CITY OF CONCORD
New Hampshire's Main Street™
Community Development Department
Planning Division

Staff Report for Planning Board

**Project Summary –Major Site Plan Architectural Design Review, and
Conditional Use Permit Applications**

Project: Phenix Block – Major Site Plan (2025-125)
Property Owner: Phenix Hall, LLC
Applicant: Northpoint Engineering, LLC
Property Address: 34-42 North Main St
Tax Map Lot: 6443Z 28

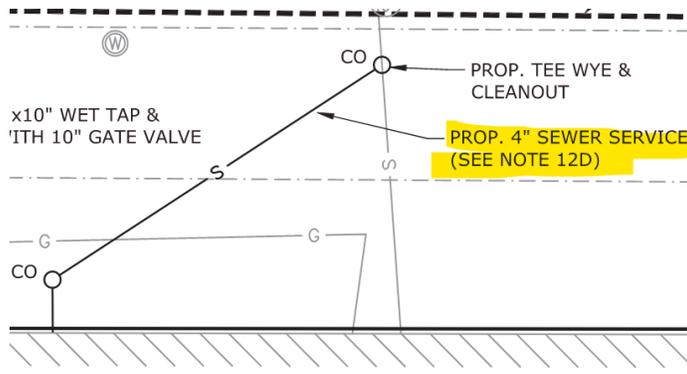
- 3.5 Section 16.02(18) *Demolition Plan* requires the demolition plan to show the extent of removal of all building, structures, pavement, and landscaping, etc. Specifically, the removal plan now provides callouts as to what will need to be removed, but does not shown the full extent of removal and restoration on the plan. A note shall be added to the removals and site plans stating to the effect that it will be the responsibility of the owner that all work related to the project,

including removal or installation of municipal or non-municipal utilities, shall be completed in one, cohesive restoration element. Additionally, a callout has been added to remove, salvage, and preserve the metal sculpture on Main Street. This sculpture is located in an area designated through an agreement between the City of Concord and the Chamber of Commerce, and the art is owned by the artist. Removal of the sculpture shall be performed in accordance with the agreement, and shall only be removed by the artist. In addition, the curbed area is designated by the City of Concord for artwork, and shall be restored to its prior condition at the completion of construction. All costs associated with the removal and restoration of the art and designated area shall be at the owner of this development project's expense. The plans shall be revised to say "Artwork to be removed by others in coordination with the City of Concord", and the plans shall be revised to show the restoration in kind of this designated art and sculpture area.

- e. Per Section 16.02(18) *Demolition Plan*, the callout for the metal art sculpture shall be revised to say “Artwork to be removed by others in coordination with the City of Concord”. Additionally, the plans shall be revised to show the restoration in kind of this designated area art and sculpture area.
